SERVICE BULLETIN

Classification: BR98-001	Reference: NTB98-023	Date: April 15, 1998
-----------------------------	-------------------------	-------------------------

1995-98 MAXIMA DASH RATTLE NOISE CAUSED BY POWER BRAKE CHECK VALVE

APPLIED VEHICLE: All 1995-98 Maxima (A32)
APPLIED DATE: Vehicles built before February 4, 1998
TRANSMISSION: Automatic transmission only

Figure 1

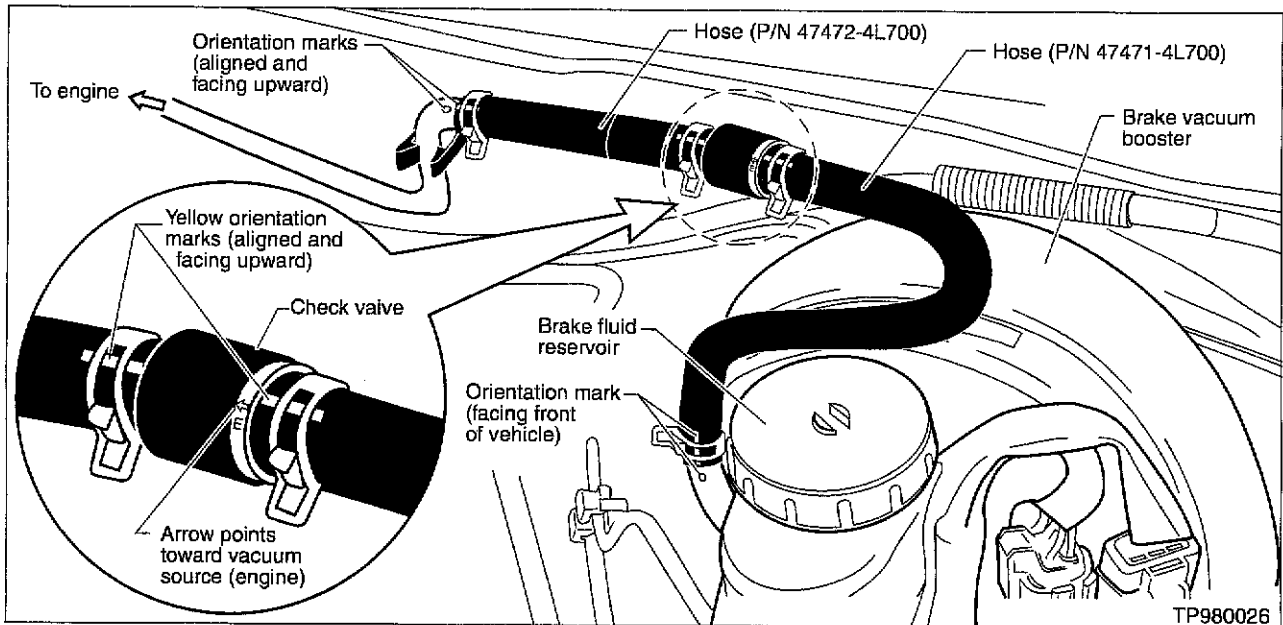
To eliminate the rattle noise, new power brake check valve hoses are now available. The new hoses are longer and dampen air flow to prevent the power brake check valve from rattling.

- A. If the rattle noise stops, replace the power brake check valve hoses (see Figure 1).

IMPORTANT: When installing the new hoses, make sure:

- The orientation marks on the hose and the mating part are correctly positioned
- There is a minimum of 10 mm clearance between the hoses and all surrounding components
- The arrow on the power brake check valve is pointed towards the engine
- There is no foreign material in the new hoses or the power brake check valve
